3. 水理模型実験の総合評価

3-2 3次元水理模型実験のモニタリング

3-4 水理模型実験の総合評価

図 3-2.11 新堰下流の水路断面流速の観測位置図

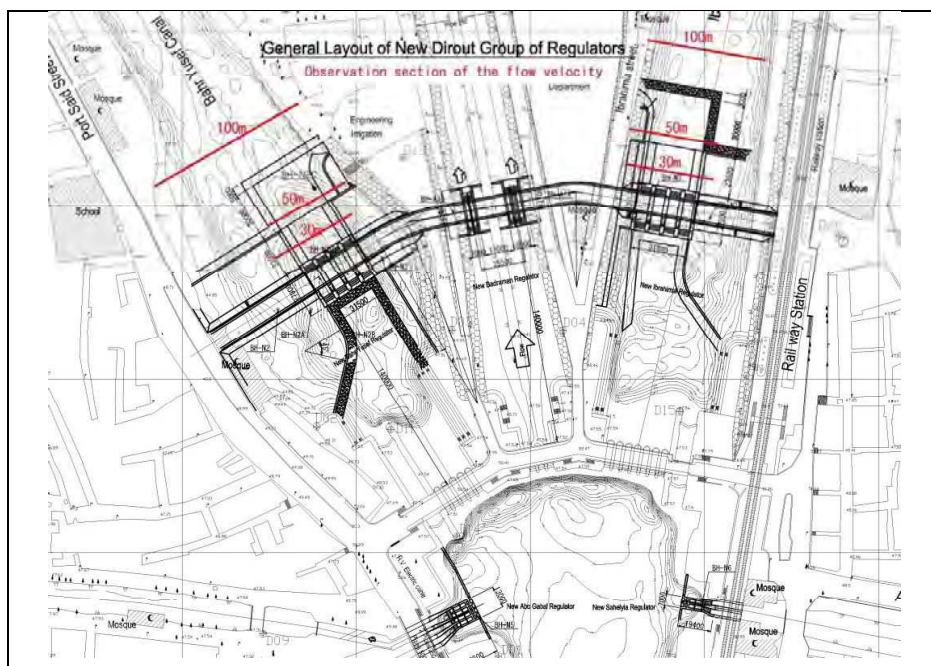
検証段階の現地確認時に RGBS から水理模型実験に関する助言を求められ、水理解析との比較のために、新バハルヨセフ堰及びイブラヒミア堰の堰軸下流 30m、50m 及び 100m 地点での流速観測を行う様に助言を行った。

流速は、マイクロカレントメーターにより新バハルヨセフ堰および新イブラヒミア堰の堰軸下流 30m、50m および 100m 地点で計測した。

図 3-2.15 検証時における既存堰下流の粗度付けの状況（ブロック設置）

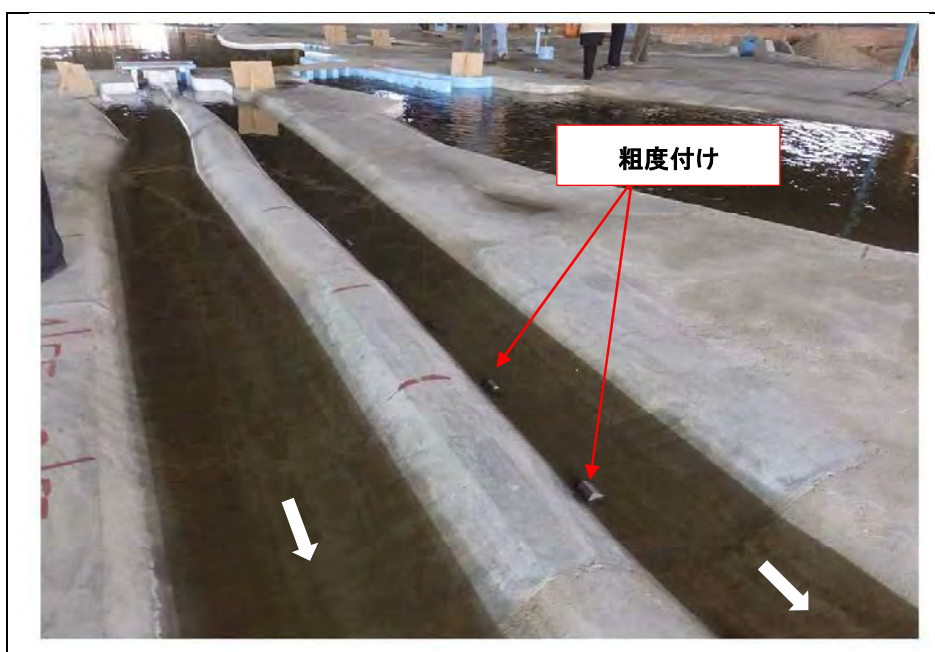
検証測線より上流で、ブロック等を貼り付ける粗度づけを行っている水路があることを確認した。この検証のための調整の範囲は、新堰設置予定地点の直下流にまで及んでいることから、計画時の流況に留意が必要であることを指摘した。

図 3-4.2 新ダイルート堰の一般図(変更後)

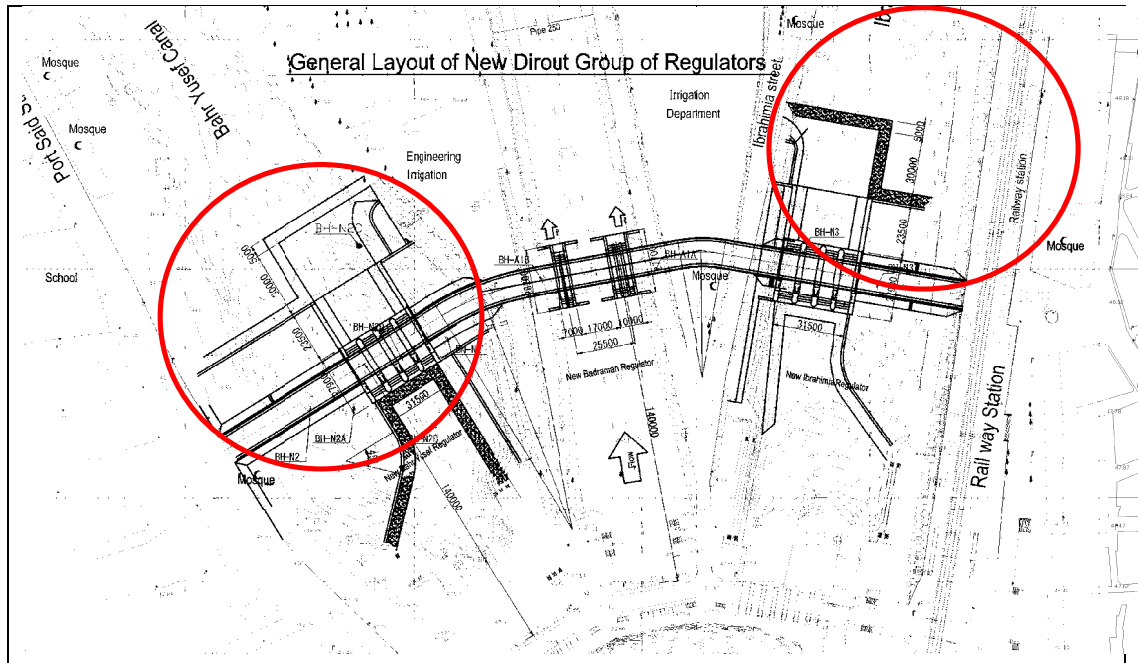
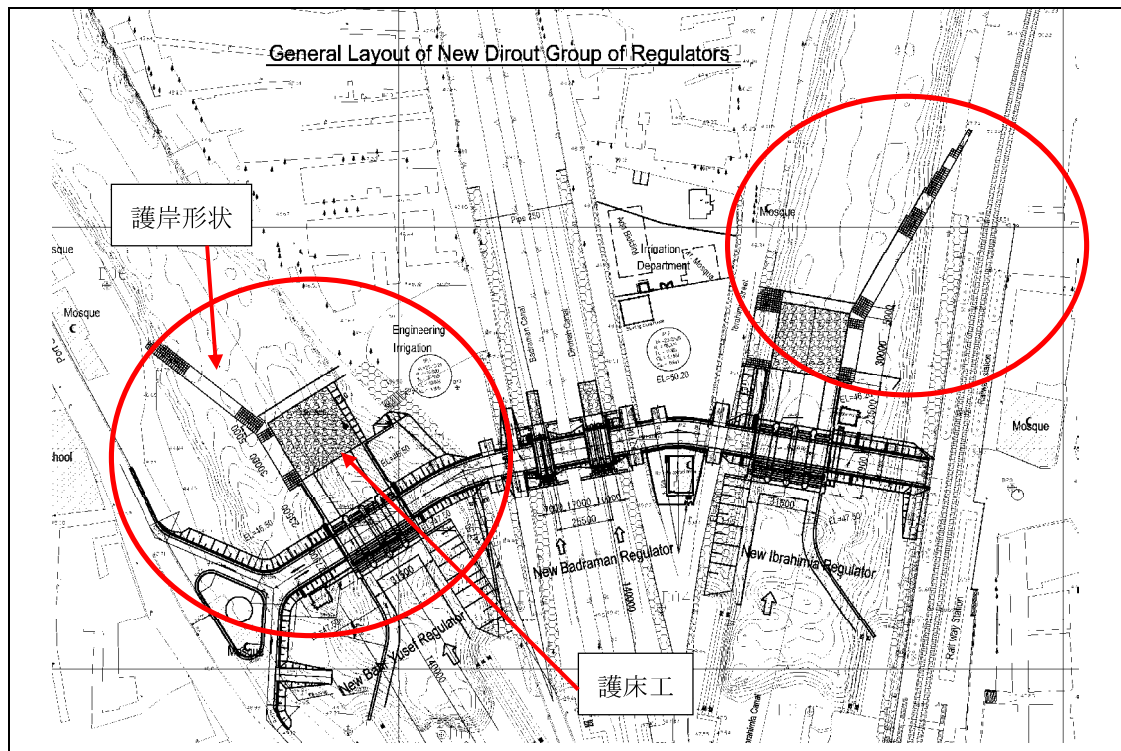
死水域の削除	<p>• バハルヨセフ水路とイブラヒミア水路の新堰下流にある死水域を取り除くことが推奨される。これは、これらの領域に充填材料（例えば、砂、シルトおよび粘土混合物）を充填し、それを水路岸の一部として考えることによって可能である。</p>	受け入れた 設計に反映する。
横断面 (1)	<p>• 横断面 (1) は、乱流および水理的に不安定な領域である。</p>	受け入れた
横断面 (1)流速	<p>• 曖昧な結果が出るため、この付近の流速分布を測定することを推奨しない。</p>	受け入れた

3次元モデルの最終報告書案では、バハルヨセフ水路とイブラヒミア水路の新堰下流にある死水域を取り除き、充填することを提言している。

提言の内容に従って、設計グループにより、この提言を検討した結果、新堰下流側の死水域を取り除き、その形状を修正した。

図 3-4.3 護床工断面図

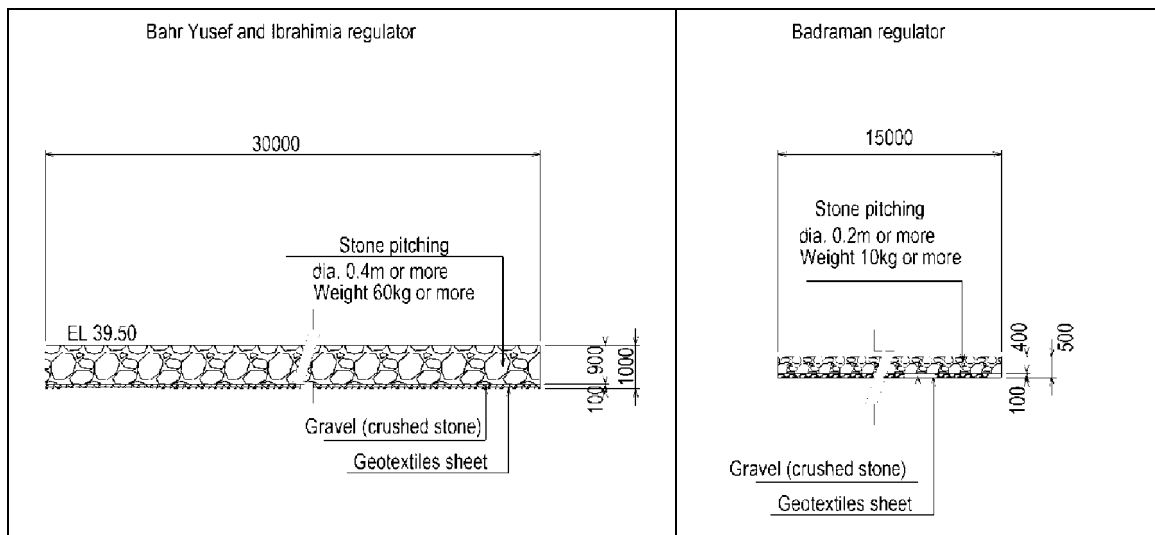
項目	提言	評価
護床工のタイプ	•エプロン下流にコンクリートブロックの領域は必要ない。それはリップラッププロテクションに置き換えることができる。	受け入れた
リップラッププロテクションの長さ	•エプロン下流のリップラッププロテクションの長さは20~30mとすることができる。	受け入れた

上記のように、2次元モデルの最終報告書案は、日本の設計基準に基づいて決定された護床工の範囲（20～30m）およびタイプを推奨している。

1) 護床工の長さ

大規模堰（バハルヨセフ、イブラヒミア）：30 m

小規模堰（バドラマン、ダイルーティア）：15 m

リップラップ
